## Department of Energy

YUCCA MOUNTAIN - REQUEST FOR ADDITIONAL INFORMATION- SAFETY  
EVALUATION REPORT, VOLUME 3 - POSTCLOSURE CHAPTER 2.2.1.3.2,  
MECHANICAL DISRUPTION OF ENGINEERED BARRIERS, 2ND SET -  
(DEPARTMENT OF ENERGY'S SAFETY ANALYSIS REPORT SECTION 2.3.4)

**RAI Volume 3, Postclosure Chapter 2.2.1.3.2, Second Set, Number 1:**

Figure 1. Deformed Shapes for TAD-bearing and Codisposal Waste Packages for Various Impact Velocities and the Associated Probability of Rupture When Subjected to Multiple Impacts

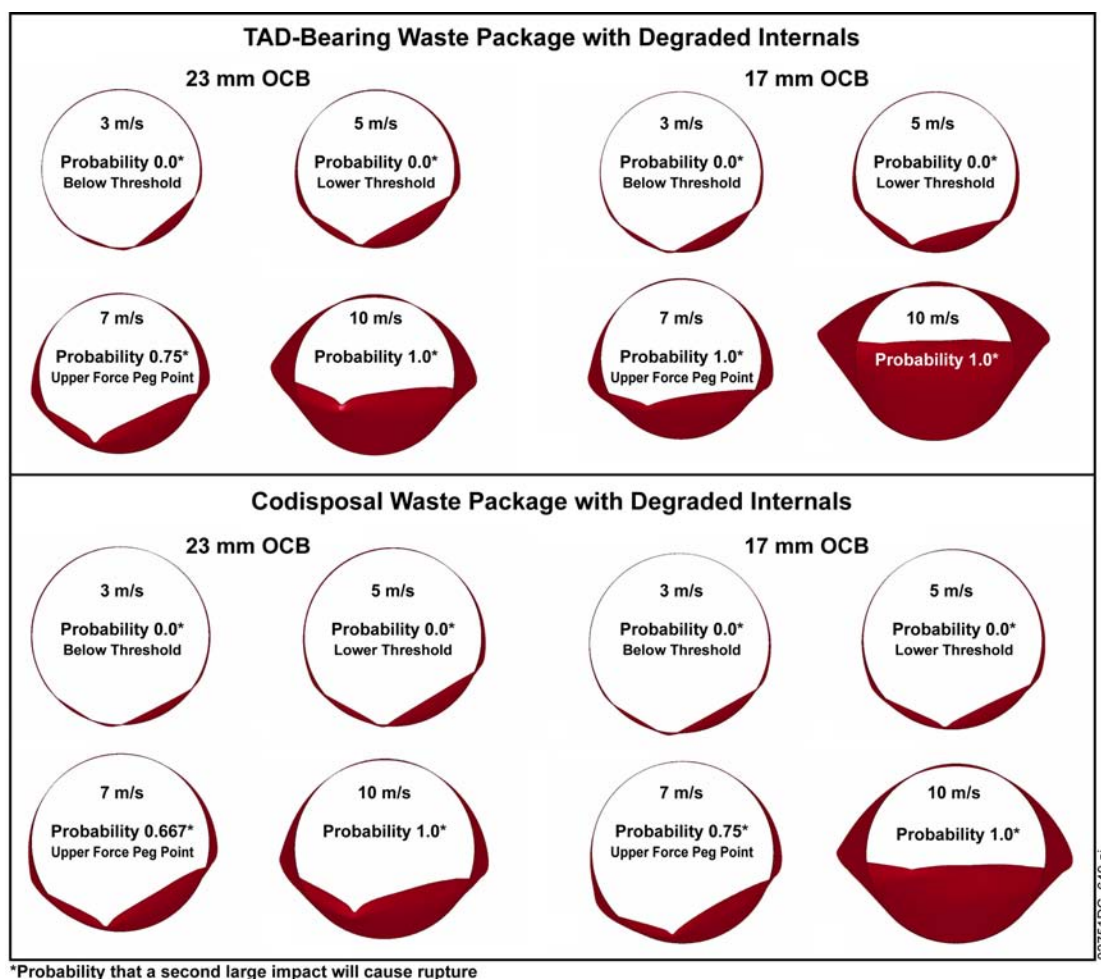
Describe the engineering parameters, such as stress or strain, that were used in the expert judgment process to determine the rupture probability for multiple impacts to waste packages.

Basis: DOE relies on engineering judgment to determine if multiple impacts to the waste package result in tensile rupture (SAR 2.3.4.5.1.4.2). If the degree of deformation from a single impact is judged significant, a second impact of equal or greater magnitude is judged sufficient to cause tensile rupture. Although DOE describes incipient damage to the waste package in SAR 2.3.4.5.2.1.3.2, DOE does not describe the magnitude of stress or strain on the outer corrosion barrier, the impact velocities that caused this damage, or the threshold in which such damage occurs. Information in the SAR does not explain how variations in these or other indicators of damage have been considered in the expert judgment process, such that the uncertainty in waste package damage potential has been considered in the analyses.

For both OCB thicknesses of the TAD-bearing and codisposal waste packages with degraded internals, deformation at an impact velocity of 3 m/s is not estimated to be severe enough to lead to rupture after multiple impacts at that level (Figure 1). However, for both OCB thicknesses of the TAD-bearing and codisposal waste packages with degraded internals, deformation increases as impact velocity increases. Deformation caused by impacts of 10 m/s is judged highly likely to cause rupture for both waste package types, and both OCB thicknesses, from multiple impacts at that velocity (Figure 1).

The deformed shapes are similar for both waste package types and both OCB thicknesses when the impact velocity is 5 m/s (Figure 1). The OCB shell starts to bulge noticeably at both sides of the deformed section, and the shell starts to have a noticeable kink where the waste package deforms into the center of the pallet cradle. It is estimated that deformation from a 5 m/s impact is a reasonable lower bound such that another impact above 5 m/s could cause a rupture of the OCB.

For impacts of 7 m/s, the degree of certainty as to whether multiple impacts at that velocity would cause rupture varies with the waste package type and OCB thickness (Figure 1). Deformation of the TAD-bearing waste package with 17-mm-thick OCB is sufficient that

multiple impacts are judged to cause rupture (probability of 1.0). However, the TAD-bearing waste package with 23-mm-thick OCB and the codisposal waste package with 23- and 17-mm-thick OCBs are estimated to have varying probabilities (that are less than 1.0) associated with how likely multiple impacts at a 7 m/s impact velocity are to cause rupture. The probabilities for the TAD-bearing waste package with 23-mm-thick OCB and the codisposal waste package with 17-mm-thick OCB are estimated at 0.75 (3-in-4 chance), and the probability for the codisposal waste package with 23-mm-thick OCB is estimated at 0.667 (2-in-3 chance). Figure 1 summarizes the probabilities of rupture from multiple impacts associated with the deformed shapes of the TAD-bearing and the codisposal waste package with degraded internals and with 23- and 17-mm-thick OCBs.

Figure 1. Effective Strain (dimensionless) as a Function of Time (seconds) for Element A27615 with Maximum Effective Strains Larger Than the Uniaxial Strain Limit of 0.57

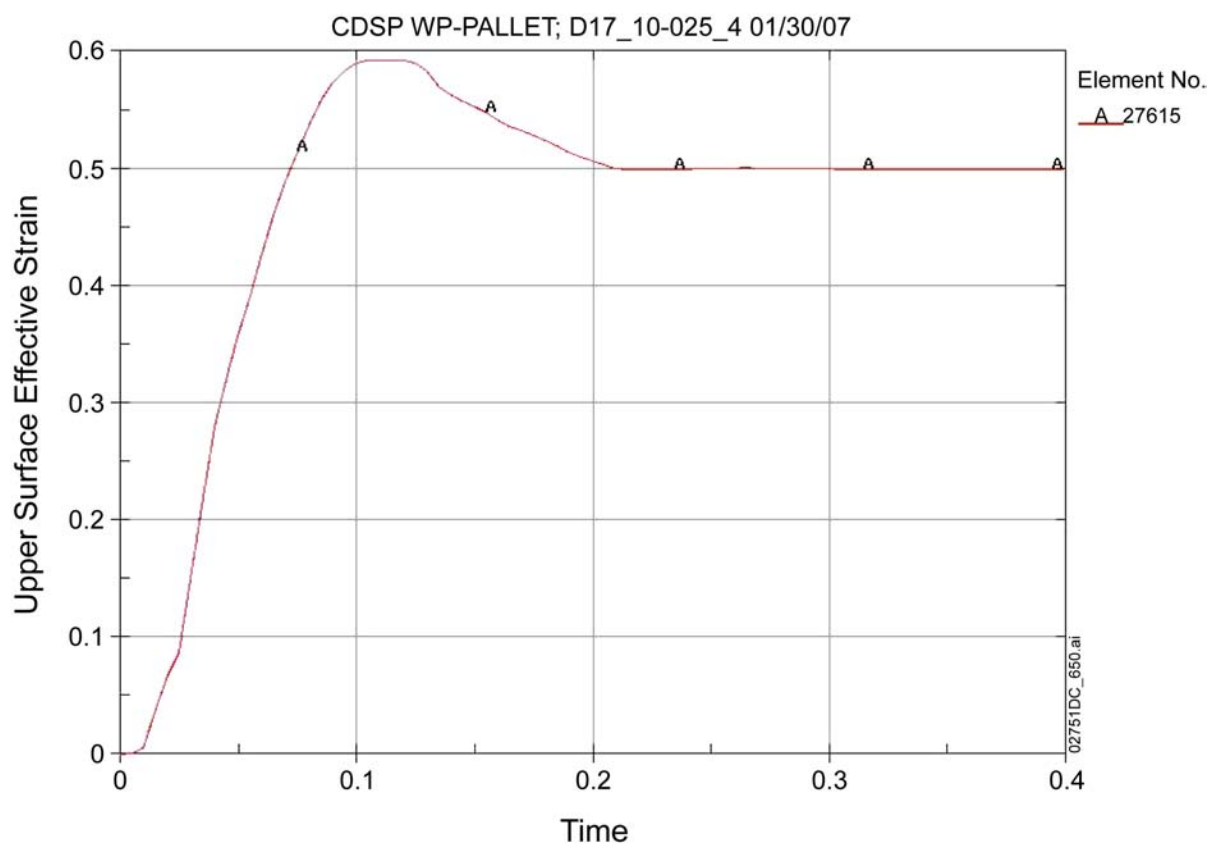
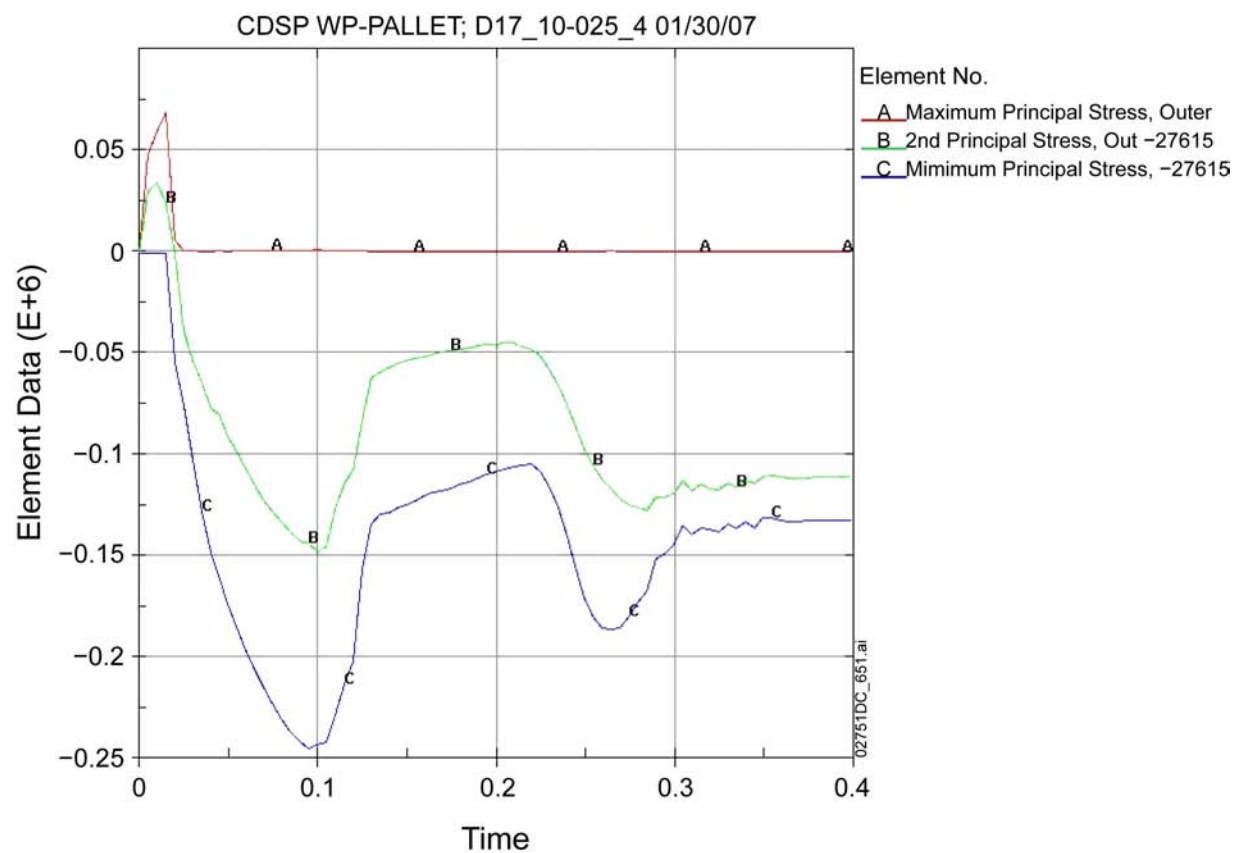
Explain why waste package rupture was excluded in the kinematic analyses for realizations where the computed maximum effective strain exceeded the effective strain limits and how this exclusion does not underestimate waste package damage. Provide triaxiality factors and deformation state (i.e., tension or compression) for realizations in which the maximum effective strain exceeded the effective strain criterion.

Basis: The applicant defined the maximum effective strain limit for the waste package rupture condition as 0.57 for uniaxial tension and 0.285 for biaxial tension (SNL, 2007, Section 6.3.2.2.5). For realizations where the maximum effective strain is less than 0.285, rupture was not considered credible. If the maximum effective strain exceeded 0.285, the strain limit was multiplied by the triaxiality factor, resulting in an effective strain limit between 0.285 and 0.57. Subsequently, the rupture condition was evaluated based on the newly computed strain limit. For some realizations the computed maximum effective strains exceed the effective strain limit (e.g., SNL, 2007, Table 6-92), however, no waste package rupture was determined for these realizations.

This behavior is illustrated by the response of the single element represented in Table 6-92 in the mechanical assessment (SNL 2007) whose maximum effective strain is 0.594. Figure 1 presents the effective strain as a function of time for this element. Figure 1 shows that the effective strain is below 0.285 for the first 0.04 seconds, so rupture does not occur initially (per the first condition in the screening process). Figure 1 also shows that after about 0.09 seconds the effective strain is greater than 0.57 for about 0.05 seconds, so the potential for rupture from uniaxial tension must be evaluated. Figure 2 presents the time-dependent behavior of the three principal stress components for this element. Although the stress state is initially tensile,  $\sigma_2$  and  $\sigma_3$  become negative (compressive) after about 0.025 seconds, and  $\sigma_1 + \sigma_2 + \sigma_3$  remains negative for all times after 0.025 seconds. It follows that the stress state is always compressive when the effective strain exceeds 0.57, so rupture cannot occur for this element.
